Kimmeridge Oil & Gas Limited
Environmental permit application to drill at
Broadford Bridge, West Sussex:

Response to the Environment Agency in the context
of relevant geology and hydrogeology

David K. Smythe

13 April 2017

Figure 2. Comparison of the original Celtique Energie well prognosis with the Applicant's prognosis. Red boxes indicate (a) the fault zone predicted by Celtique where section will be missing, and (b) text on the right where the Applicant expects to penetrate a fault zone.

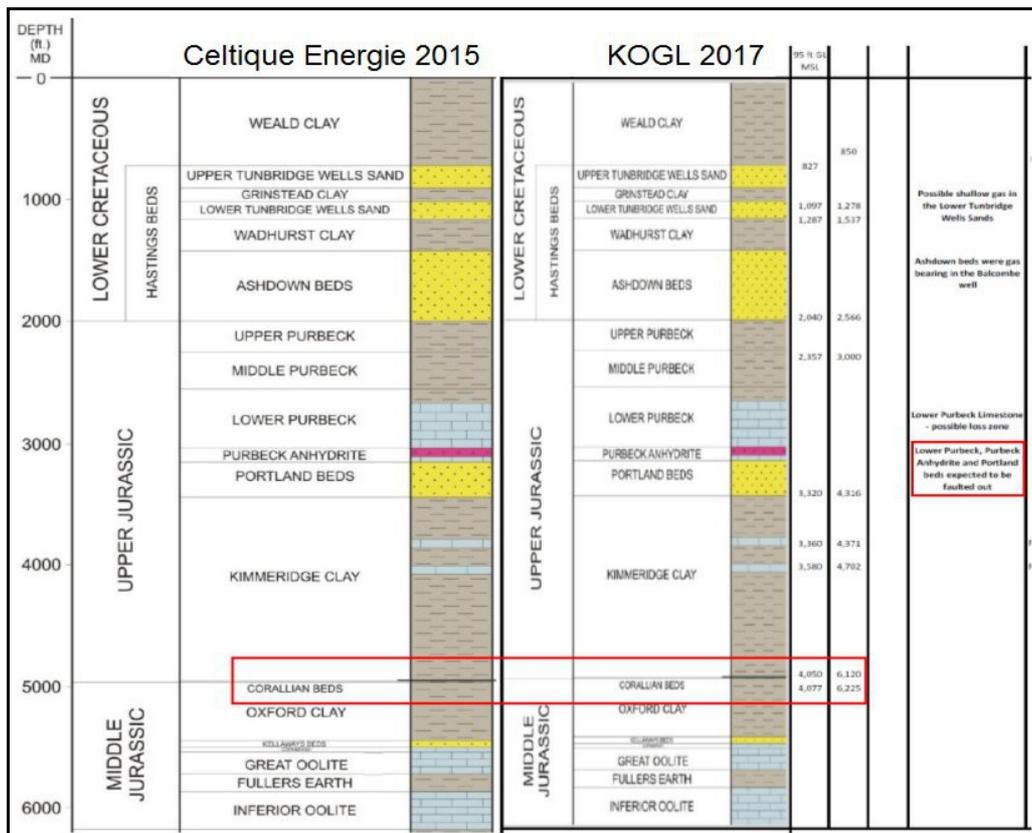
In 2015 Celtique Energie submitted a geological log prognosis of its proposed drilling (*HSEC-BB-PD-01 Environmental Method Statement Drilling*). The geological column from figure 4.2 of this document is shown in the left-hand side of Figure 2. Depths in feet on the left are driller's depths, i.e. along the somewhat deviated well, and not vertical depths. A complete stratigraphic succession was expected to be encountered, except where the drill would penetrate the Broadford Bridge Fault at around 5000 ft. Some of the Corallian and Great Oolite would be missing, as indicated by the horizontal black line highlighted within the red rectangle.

The right-hand side of Figure 2 shows that the Applicant has simply re-used the same diagram, but with different depth figures shown on the right. There are two columns; the true vertical depth, and the driller's depth measured along the hole, on the left and right, respectively. Analysis of these figures shows that the Applicant is planning a highly deviated hole. It also expects to penetrate a fault zone, where it states (as highlighted in the red rectangle of Figure 2) "*Lower Purbeck, Purbeck Anhydrite and Portland beds expected to be faulted out*". These layers, shown in light blue, crimson and yellow in the middle of the geological column, should therefore have been omitted from the column. In contrast, the rock layers correctly omitted by Celtique in its column on the left (within the lower red rectangle) should properly have been included in the column on the right.

We do not know where it is then directed, because, according to the well prognosis in Figure 2, it should then proceed to penetrate the Oxford Clay or Lias. On the upthrown (north) side of the fault this would be at a depth of 6500 ft – implying an abrupt vertical depth jump of 2500 ft. In short, the well prognosis by the Applicant does not make sense below the KCF.

Figure 3. Celtique Energie interpretation of geology along section AA' (Fig. 1) showing original well track and new welltrack proposed by the Applicant. KCF – Kimmeridge Clay Formation.

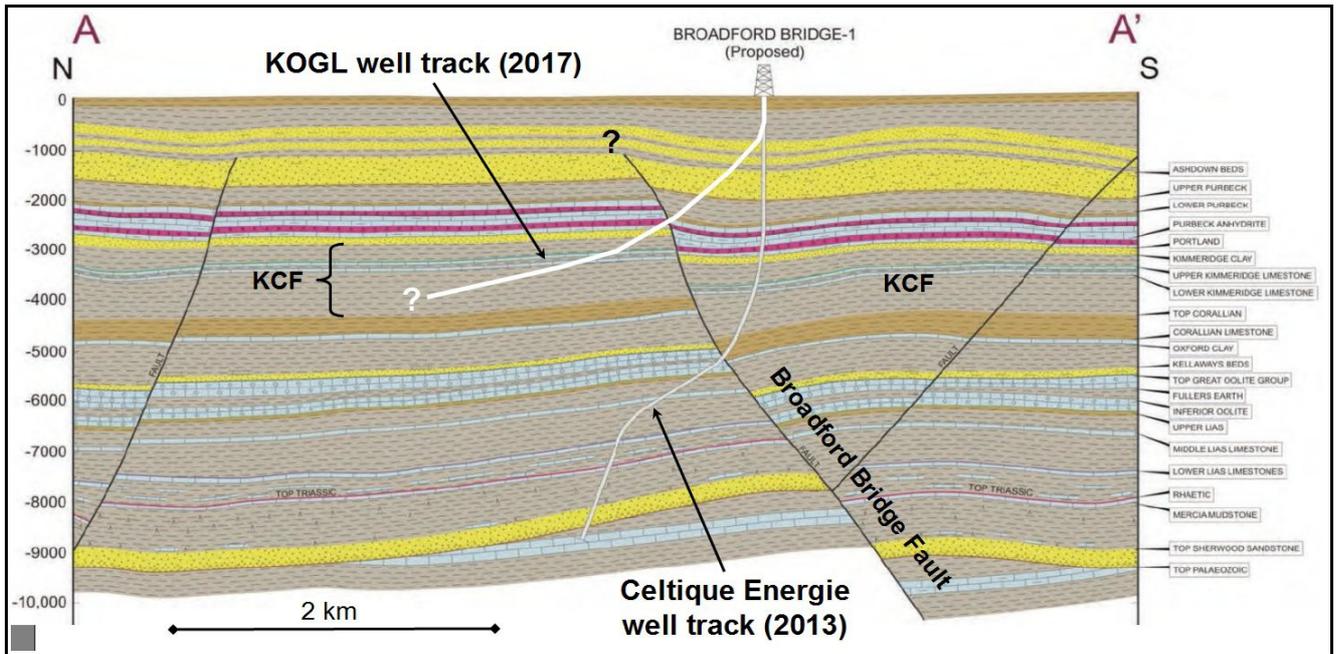
The result of the analysis is shown in Figure 3, which is a Celtique Energie cross-section with the new proposed well track added. The Celtique well penetrates nearly vertically to about 5000 feet, then passes through the Broadford Bridge Fault into the footwall side on the north.

The Applicant's well is proposed, in contrast, to deviate significantly from just below the surface, and then pass through the Broadford Bridge Fault at a much shallower depth than the Celtique proposed wellbore. It then penetrates the Kimmeridge Clay Formation (KCF), with its two thin so-called limestone beds, at an oblique angle.

The Applicant intends to drill through the Broadford Bridge Fault at around 2500 ft depth (Fig. 3), but at a location some 500 m east of the nearest seismic line. The interpretation of the geology by Celtique Energie, shown in Figure 3, is based on the new seismic line CE-11-02 which they acquired in 2011. But it should be noted that such an interpretation is far from being a fully accurate cross-section of the geology. The raw data for this line are shown in Figure 6, which I have mirror-imaged so that it matches the geological interpretation, with north placed on the left. The vertical scale is in milliseconds of two-way reflection travel time (TWT), with zero being at sea level. The base of the seismic data of Figure 6, at around 1300

Figure 4. Generalised locations of seismic reflection data (dotted green lines) around Broadford Bridge-1. Grid is at a 1 km interval. OS map base copyright acknowledged.

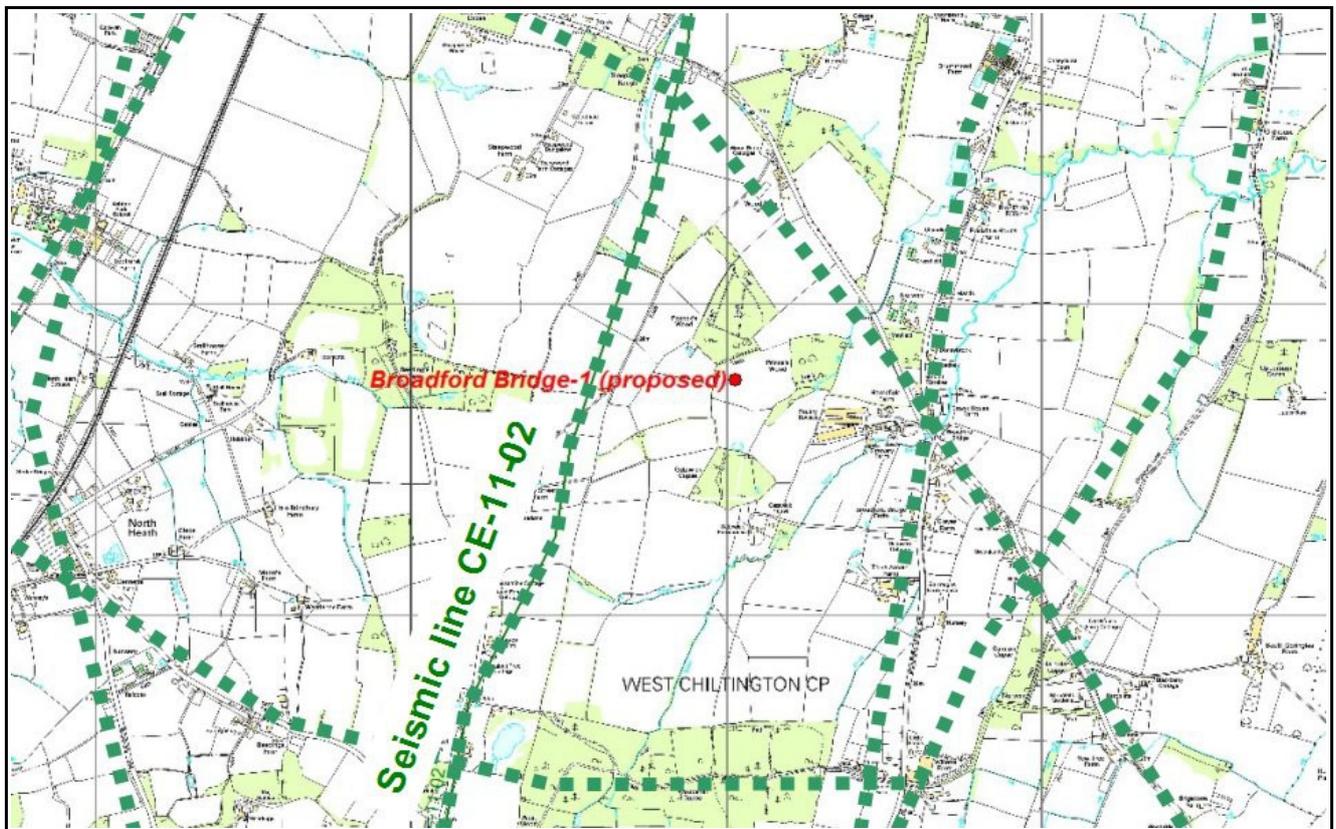
Figure 4 shows a map of the proposed well location, with generalised seismic lines shown by the thick dotted green lines. Several of these tracks have multiple seismic lines along them, dating from different epochs. A couple of very early seismic lines, dating from 1962, have been omitted, as they are of such poor quality as to be useless. The nearest line to the wellpad is the recent Celtique Energie line CE-11-02. It passes 500 m to the west of the surface location of the well.

Not only will the Applicant's well start at 500 m east of the nearest seismic line, but it will follow a northward trajectory, passing through the Broadford Bridge Fault zone, and only

crossing one other seismic line, which runs NW-SE at about 800 m north of the drillpad. So the Applicant will be drilling 'blind', relying on (i) drill cuttings and (ii) a set of directional gamma-ray detectors to determine the geology at any moment. These two tools work passably well when the geology is simple, and one knows in advance what layering to anticipate, but will fail if a fault is traversed.
